# Access Compliance Report

## Public Rights-of-Way

### (Curb Ramps)

Intersection ID: 14983	Main Street: COOK_ST	Cross Street: S_LAUREL_AV	Location:	N
ADA ID: C0D5D4FA8483	Ramp Type: Directional1	Initial Pass/Fail: Fail	Overall Compliance: No	Severity Score: 25

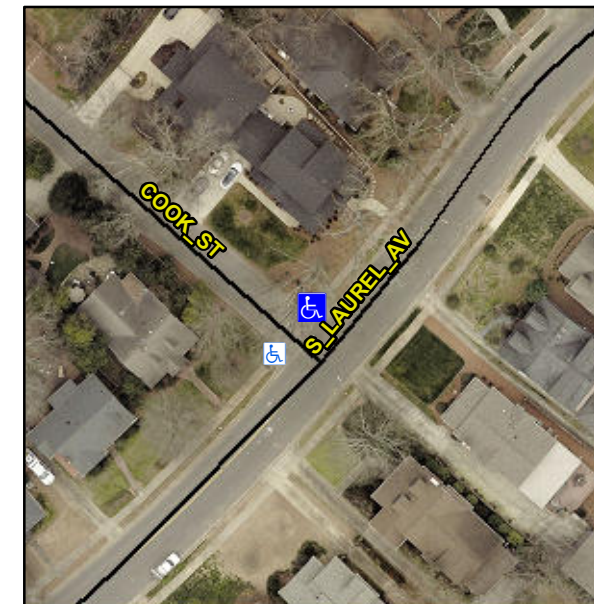
**R304.5.3**

Compliance	Description	Data	Compliance	Description	Data
N/A	Ramp Length (in)	43.0	N/A	Grade Break?	N/A
Yes	Ramp Width (in)	48.0	N/A	Grade Break Slope (%)	0.0
Yes	Ramp Slope (%)	0.8	N/A	Grade Break XSlope (%)	0.0
No	Ramp XSlope (%)	14.9			
N/A	Flare Type LT	N/A	N/A	Flare Type RT	N/A
N/A	Flare Slope LT (%)	N/A	N/A	Flare Slope RT (%)	0.0
N/A	Flare Traversable LT?	N/A	N/A	Flare Traversable RT?	N/A
N/A	Landing Length (in)	0.0	N/A	DWS Provided?	N/A
N/A	Landing Width (in)	0.0	N/A	DWS Contrast?	N/A
N/A	Landing Slope (%)	0.0	N/A	DWS Length (in)	N/A
N/A	Landing X Slope (%)	0.0	N/A	DWS Full Width?	N/A
N/A	Landing Curb? (Y/N)	N/A	N/A	DWS Offset LT (in)	N/A
N/A	Shared Landing?	N/A	N/A	DWS Offset RT (in)	N/A
N/A	Gutter Ponding?	0.0	N/A	Gutter Slope (%)	N/A
N/A	Gutter Lip Ht (in)	0.0	N/A	Gutter X Slope (%)	N/A
N/A	Painted X Walk1?	No		Road Slope (%)	0.7
	X Walk 1 Direction	To SW		Road X Slope (%)	9.2
	X Walk 1 Width (in)	N/A		Clear Space?	N/A

**Remove & Replace Entire Ramp.**
